STRUCTURAL PEER REVIEW STATEMENT

Project Address: 11 Hoyt Street, Brooklyn, NY, Block# 157, Lot# 1

**11 Hoyt Street, Brooklyn, NY
Structural Peer Review Report**

11 December 2017

Figure 7 – Location of Mat Foundation One-Way Shear Checks (from FO-100.00)

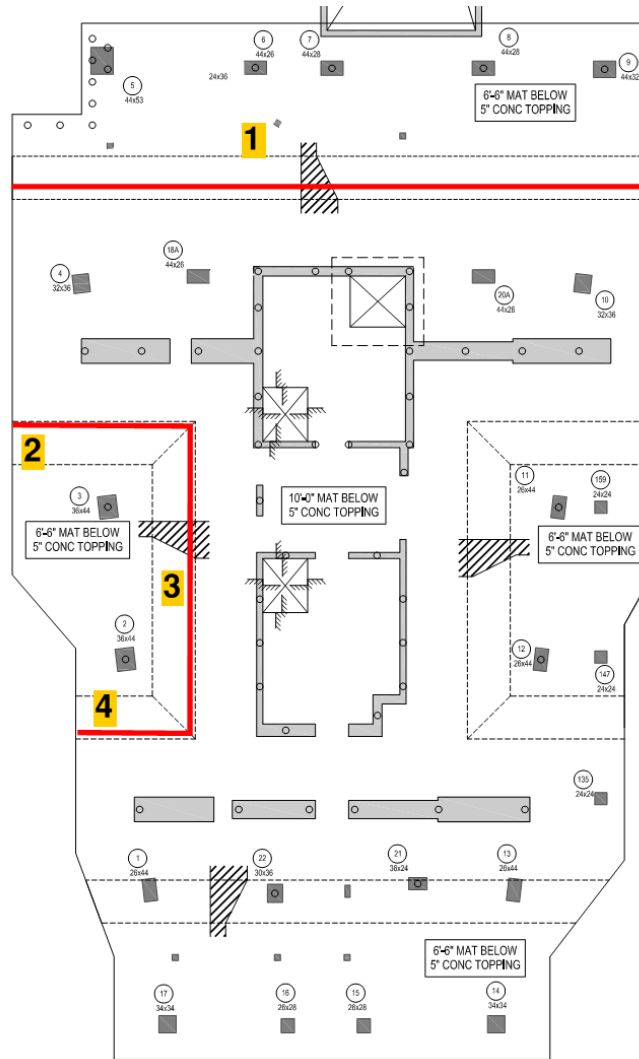
The drawings do not clearly indicate the layout of shear reinforcement. We recommend additional shear reinforcement detail to further explain the arrangement. However, from the sample calculations, we believe the shear design of the mat foundation is adequate in one-way shear.

Figure 8 – Critical Perimeters for Two-Way Shear Check of C5 and GIEs at NW Corner

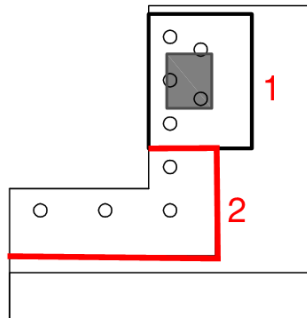
We find that the slab around C5 is overstressed under the combination of unbalanced moment and shear force. The shear stress, calculated considering the moment in N-S direction, exceeds the maximum shear capacity of the 6'-6" slab. We recommend that the EOR increase the slab thickness for this local area around NW corner and revise the design of shear reinforcement considering the unbalanced moment. For other reviewed locations, we believe the punching shear capacity of slab around the columns and GIEs is adequate.

Figure 13 - Location of Slab Reinforcement Checks (from S-320.00)

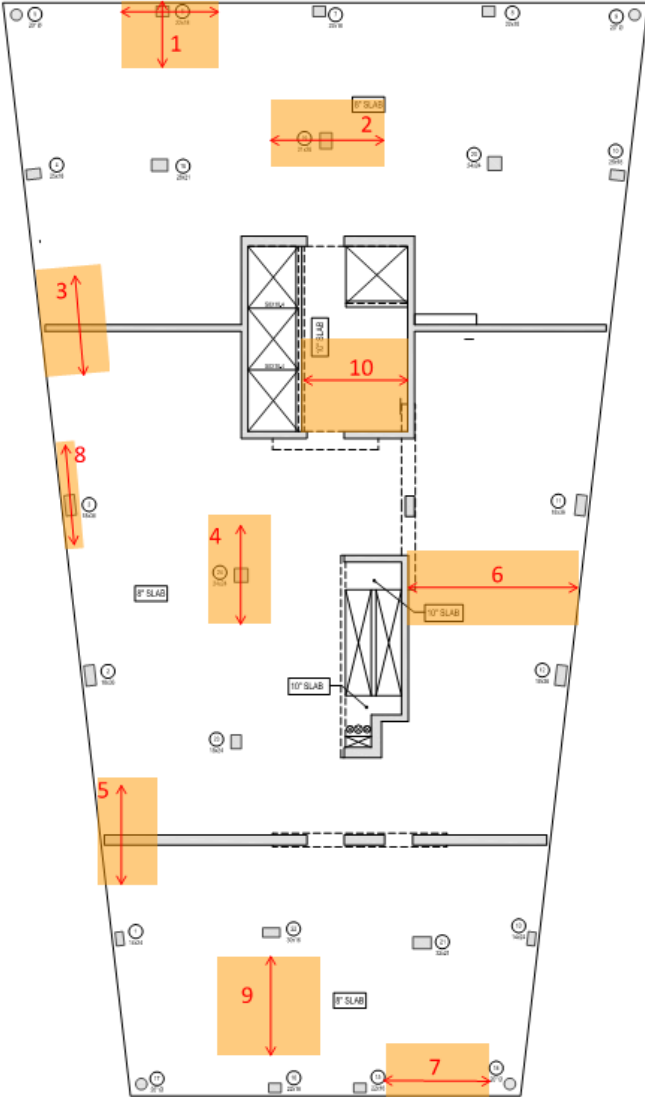
From the sample calculation, we find that the flexural design of slab is adequate at most locations. However, a portion of the slab at the southern east-west wall is somewhat locally overstressed under negative bending moment in the N-S direction. We did not apply the code provisions for load redistribution to determine whether the column bay is adequate overall; we suggest that the EOR review the flexural capacity in this area of the slab.
